1. NEC Cardbus Board/BOM Change Notice

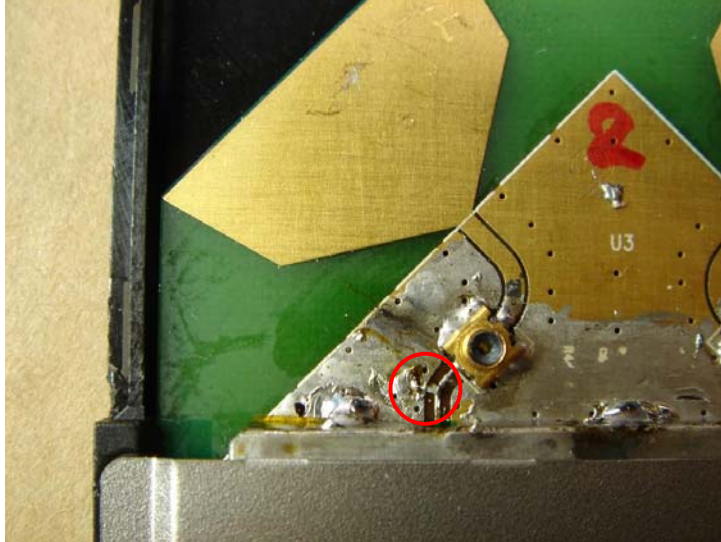
- (1) Added UWB filters at RF output paths to lower out-of-band emission noise level.
- (2) Added tuning inductor at radiating channel for flattening in-band signal.

- (3) Tied digital ground and analog ground together for removal of low frequency spurs.
